# Access Compliance Report

## Public Rights-of-Way

### (Curb Ramps)

Intersection ID: 46190	Main Street: YAUPON_RD	Cross Street: LUSTRE_RD	Location: NE
ADA ID: D912FD8EB07D	Ramp Type: BlendTrans1	Initial Pass/Fail: Fail	Overall Compliance: No
Severity Score: 1.25			
Codes/Mitigation Info/Possible Solution		Field Measurements/Component Compliance

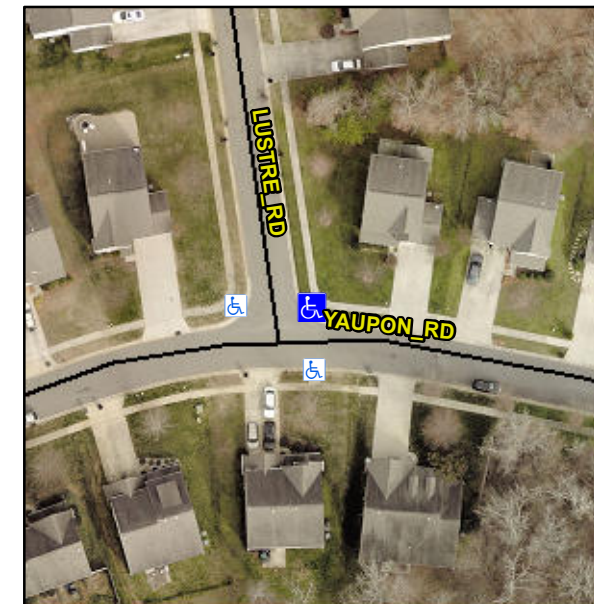
**Remove & Replace Curb Ramp With Two New Directional Ramps or Equivalent.**

**CURB WIDTH 44.0**

**Not Found, R304.5.3**
